Our Ref: 20-12/001182
CRC Ref: mcuc 2021_4490/1
Date: 18 March 2022

RE: RESPONSE TO INFORMATION REQUEST IN RELATION TO AN APPLICATION FOR MATERIAL CHANGE OF USE FOR 'MULTIPLE DWELLINGS' AND 'SHORT-TERM ACCOMMODATION' OVER LAND AT 69 – 73 MURPHY STREET, PORT DOUGLAS

We hereby provide the following information in response to Council's Information Request dated 22 December 2021.

DA03.001

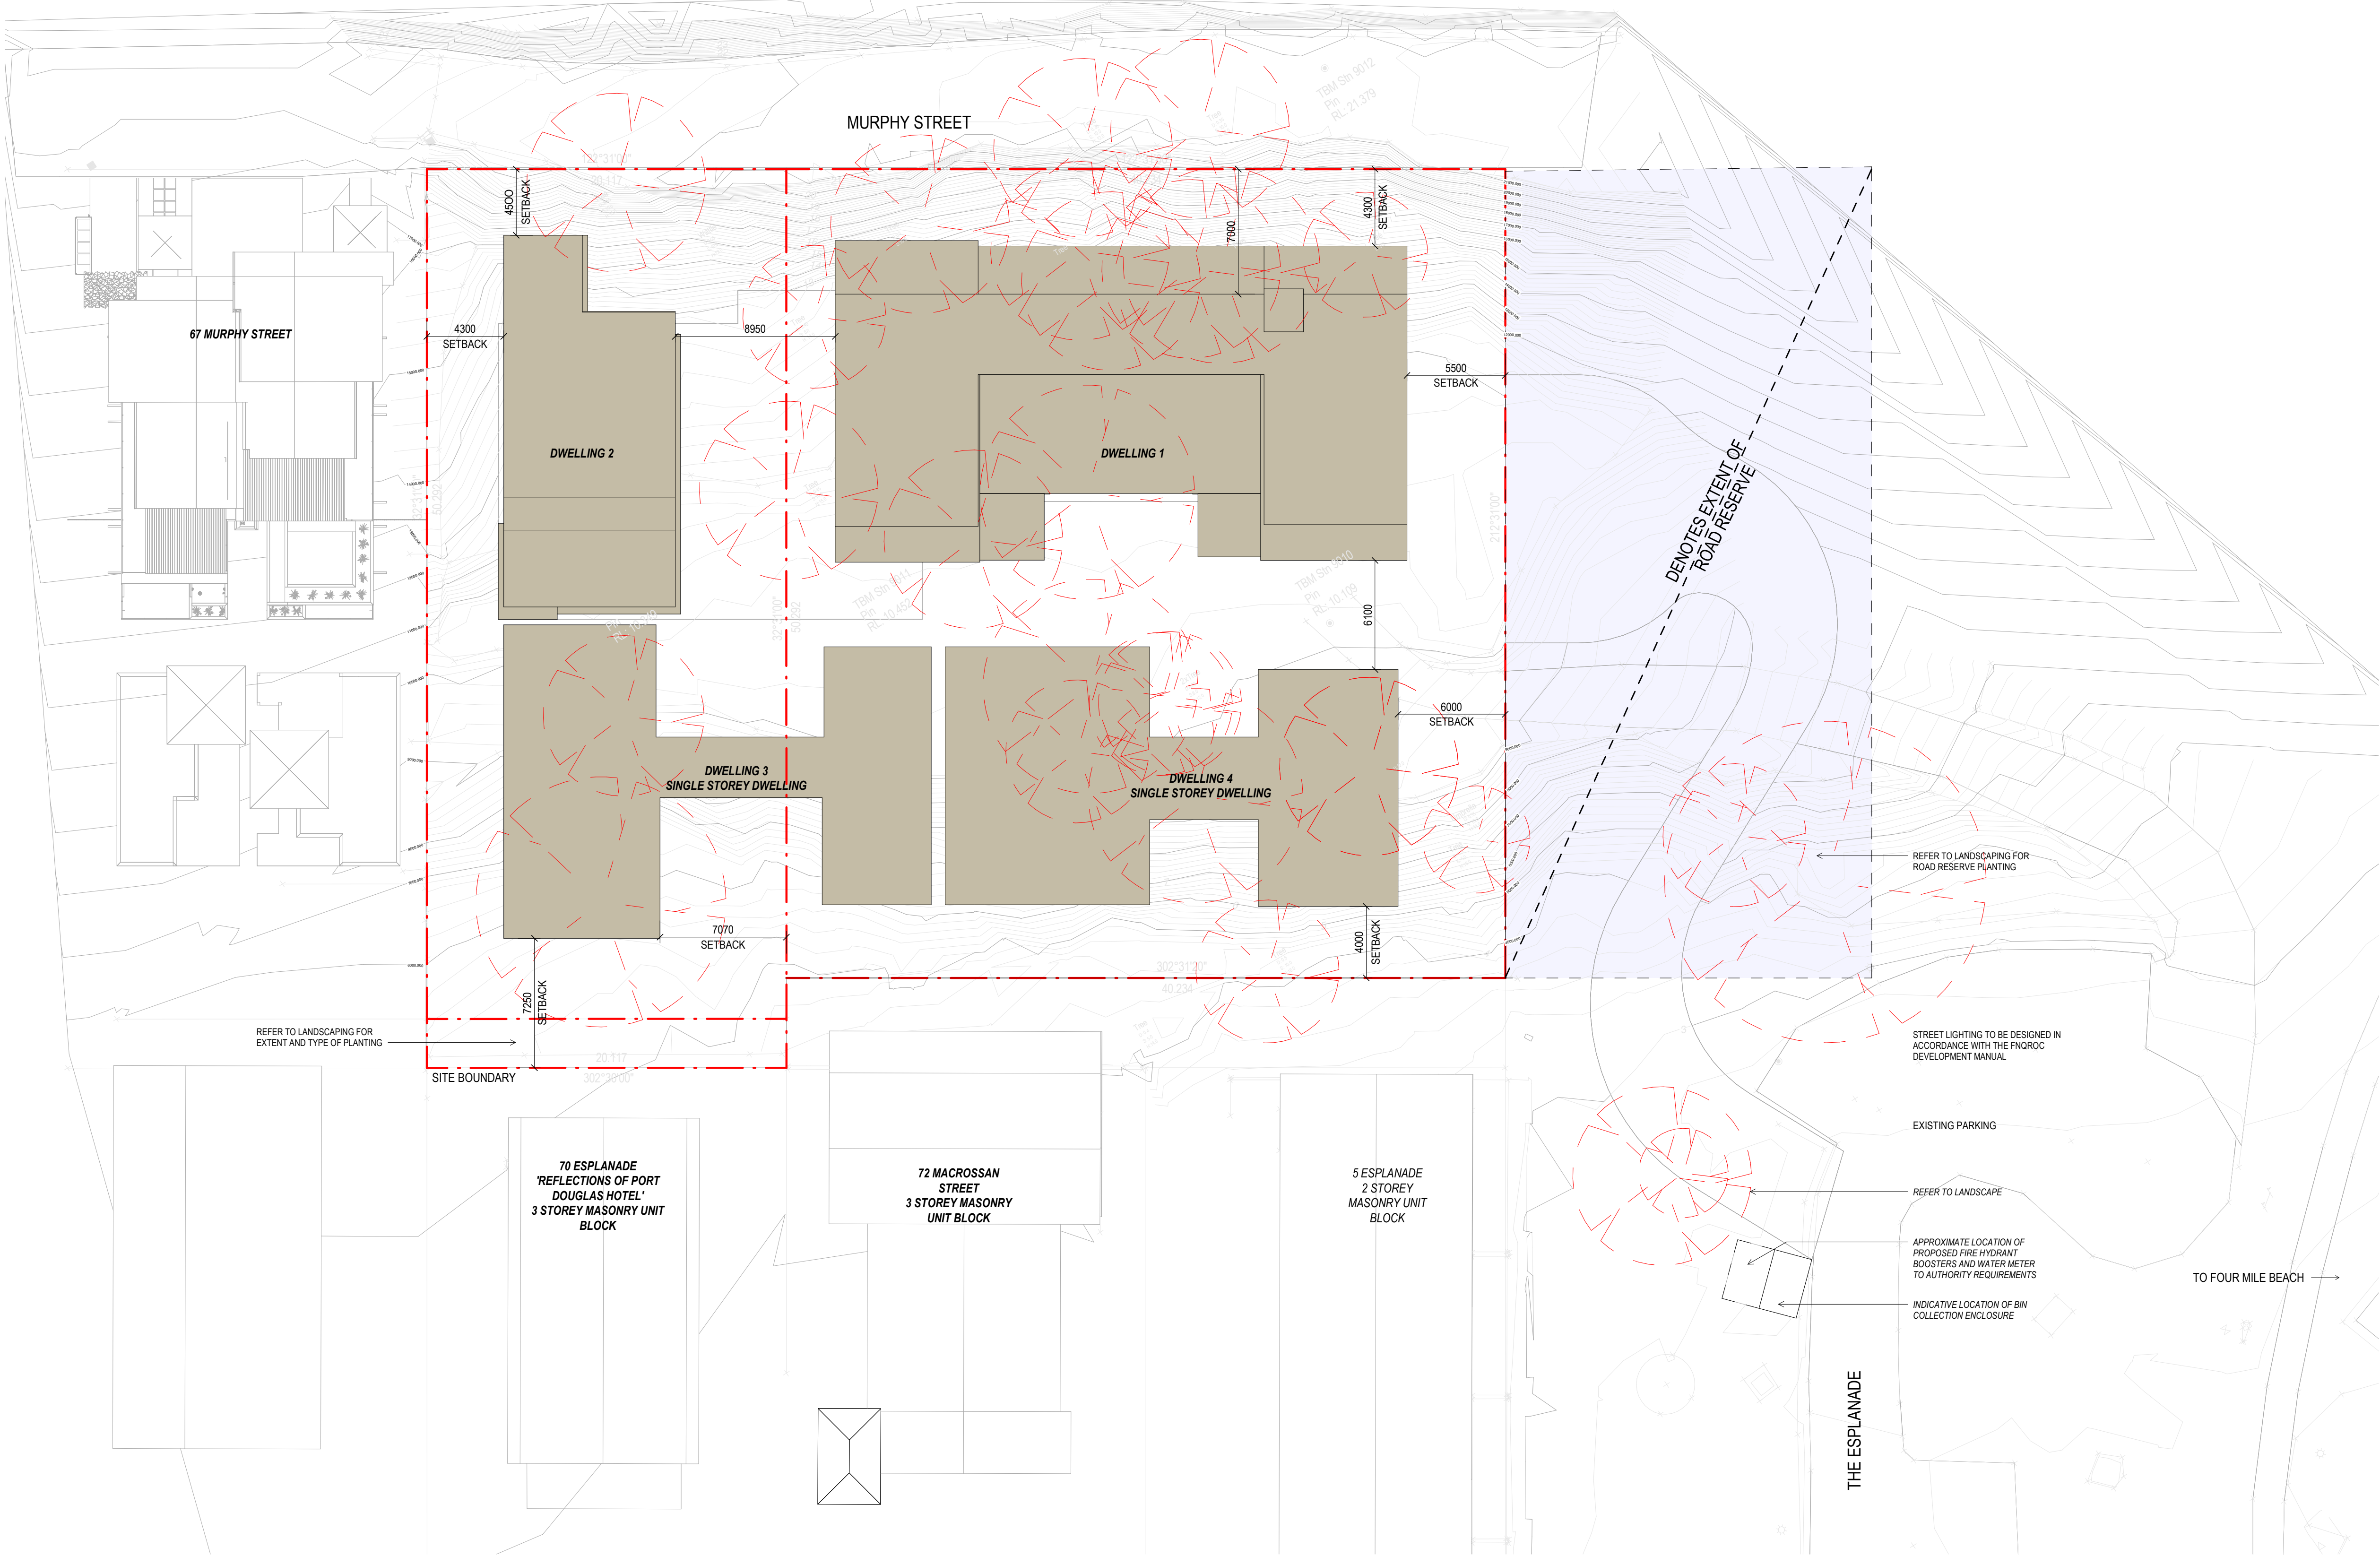
4. The application does not include plans and details of the access into the site. Detail of the access driveway east from the extent shown on drawing DA010.01 is required. It is noted that the access will be in road reserve and the previous approval issued over the site required this road to be constructed to an access street standard. Particular design details is required from the Applicant regarding the design of the access, departure from FNQROC Development Manual if proposed, and ongoing maintenance obligations post construction and ability for the access to accommodate refuse vehicles. Details on all existing vegetation to be removed and / or compromised is also required.

Please see revised Architectural Plans included as **Annexure 1**, Engineering Services Report included as **Annexure 3**, Traffic Engineering Assessment included as **Annexure 4** and Landscape Plans included as **Annexure 5**.

- Architectural Drawings DA03-001 & 002 illustrate the proposed general arrangement;***

DA010.01

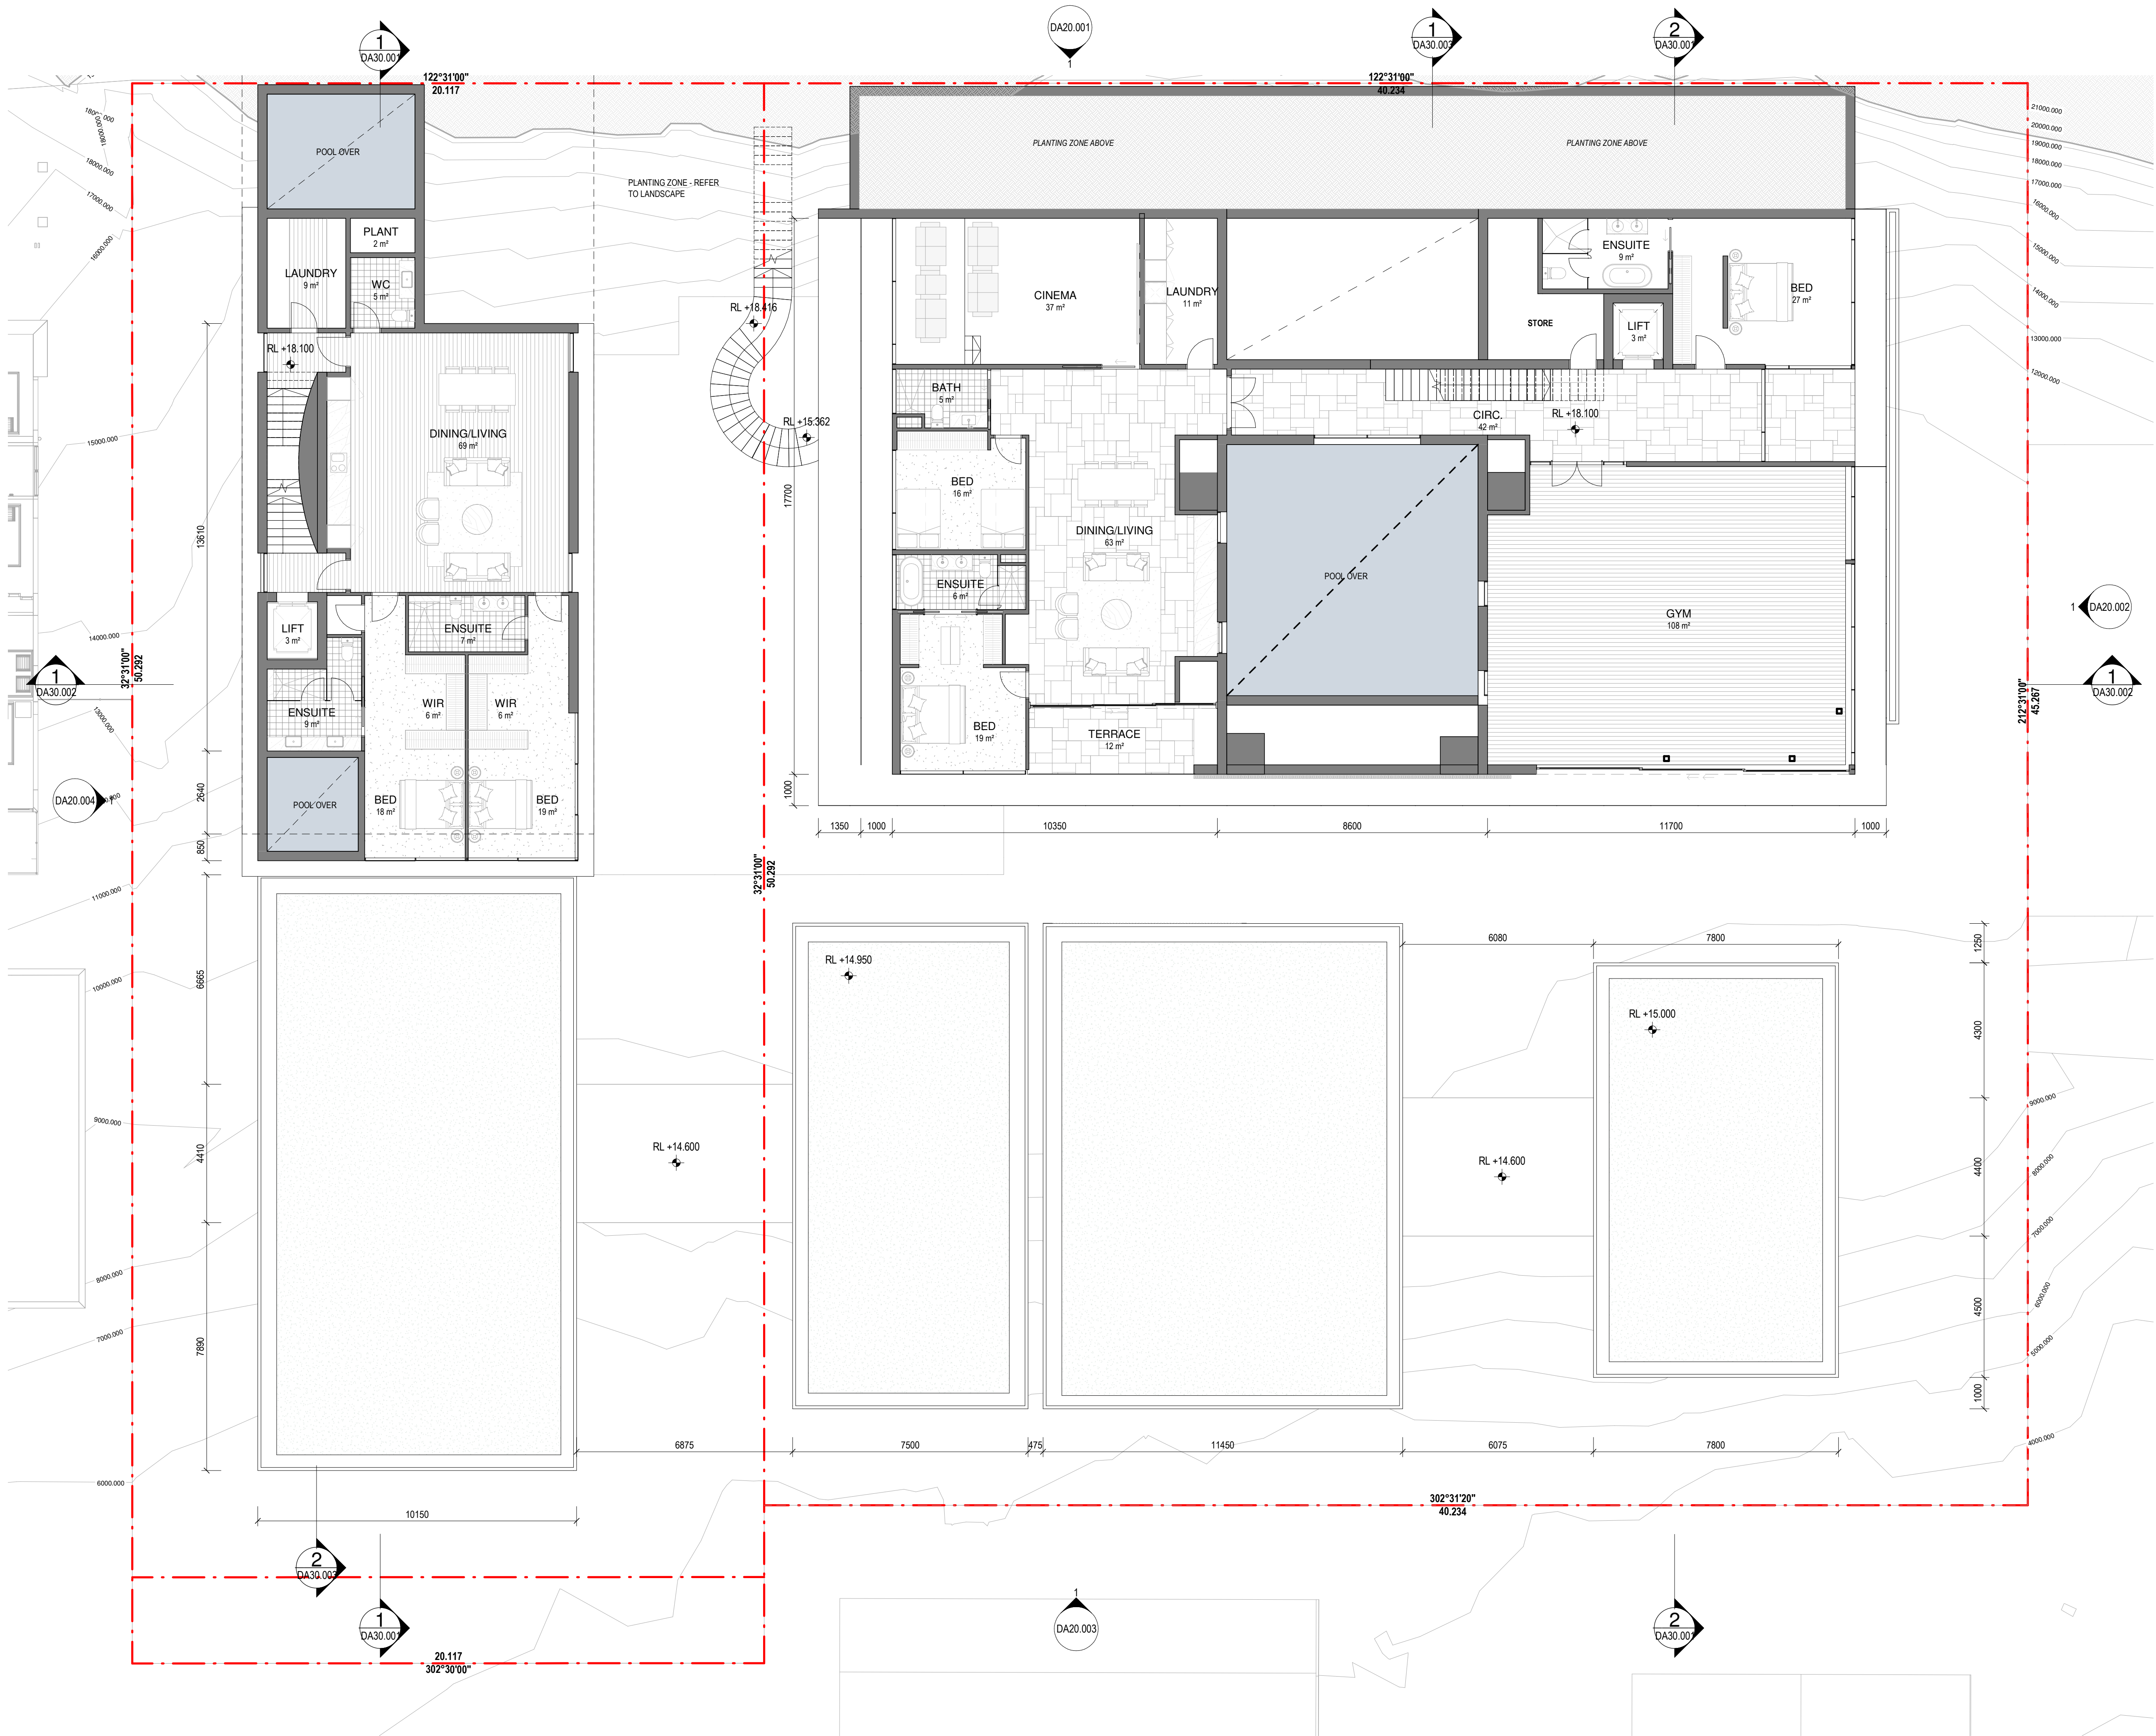
3. Drawing DA010.01 (Lower Floor plan) appears to show columns for the subsequent levels of the development being located within the internal driveway and in front of garages. The applicant is to review the location of columns and confirm that all garages are able to be accessed in accordance with the requirements of AS2890.1 – Off Street Parking Code and AS2890.6 – Parking Facilities – Off-Street Parking for people with disabilities. Swept path diagrams are also required. Supporting information is also to show how the development is serviced by refuse vehicles.

5. With reference to drawing DA010.01, the application does not demonstrate how it will provide for disabled access to the site and the buildings as required for this development classification. Visitor parking and compliant accessible path of travel from the parking will need to be demonstrated in the proposed layout.

Please see Traffic Engineering Assessment included as **Annexure 4**. The report confirms that the parking layout complies with AS2890.

The applicant hereby seeks to amend the application to no longer include the Short-Term Accommodation component. Moving forward, the application seeks approval for Multiple Dwellings only. We understand that as this change is in response to an Information Request, it will not impact on the current development assessment process.
